# Access Compliance Report

## Public Rights-of-Way

### (Curb Ramps)

Intersection ID: 17967	Main Street: MONROE_RD	Cross Street: WALLACE_RD	Location: SE
ADA ID: F39A226639EC	Ramp Type: MedianPerp	Initial Pass/Fail: Fail	Overall Compliance: No
Severity Score: 26.25			
Codes/Mitigation Info/Possible Solution		Field Measurements/Component Compliance

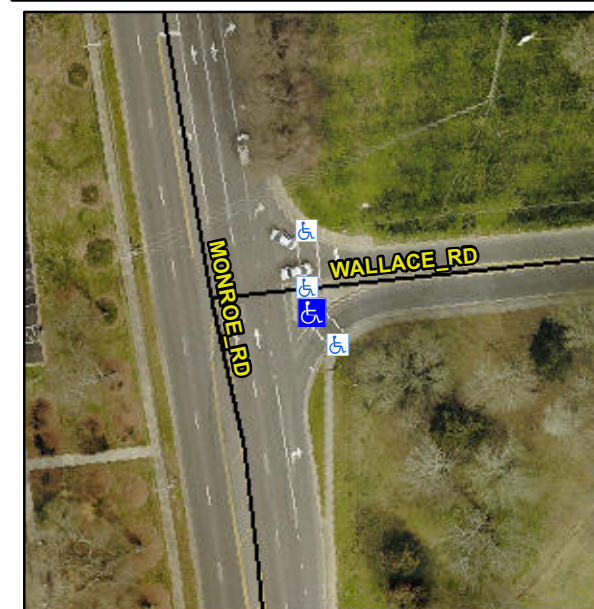
**Not Found, R304.2.2, R304.5.3**

Compliance	Description	Data	Compliance	Description	Data
N/A	Ramp Length (in)	44.0	No	Ramp Slope (%)	14.9
Yes	Ramp Width (in)	48.0	No	Ramp XSlope (%)	2.2
N/A	Flare Type LT	N/A	N/A	Flare Type RT	N/A
N/A	Flare Slope LT (%)	N/A	N/A	Flare Slope RT (%)	N/A
N/A	Flare Traversable LT?	N/A	N/A	Flare Traversable RT?	N/A
N/A	Landing Length (in)	N/A	N/A	DWS Provided?	N/A
N/A	Landing Width (in)	N/A	N/A	DWS Contrast?	N/A
N/A	Landing Slope (%)	N/A	N/A	DWS Length (in)	N/A
N/A	Landing X Slope (%)	N/A	N/A	DWS Full Width?	N/A
N/A	Landing Curb? (Y/N)	N/A	N/A	DWS Offset (in)	N/A
N/A	Shared Landing?	N/A			
N/A	Gutter Ponding?	N/A	N/A	Gutter Slope (%)	N/A
N/A	Gutter Lip Ht (in)	N/A	N/A	Gutter X Slope (%)	N/A
N/A	Painted X Walk1?	Yes	N/A	Painted X Walk2?	N/A
	X Walk 1 Direction	To SE		X Walk 2 Direction	N/A
N/A	X Walk 1 Width (in)	114.0	N/A	X Walk 2 Width (in)	N/A
	X Walk 1 Slope (%)	1.8		X Walk 2 Slope (%)	N/A
	X Walk 1 X Slope (%)	1.9		X Walk 2 X Slope (%)	N/A

N/A	Ramp inside XWalk1?	Yes	N/A	Ramp inside XWalk2?	N/A
	Road Slope (%)	N/A	N/A	Clear Space?	N/A
	Road X Slope (%)	N/A	N/A	Clear Space to XWalk (in)	N/A
N/A	Any Obstructions?	N/A	N/A	Storm Grate/Utility Hazard?	N/A
	Obstruction Type			Storm Grate/Utility Type	
		N/A			N/A
			Yes	Surface Condition? (G/P)	Good

**Remove & Replace Entire Ramp.**
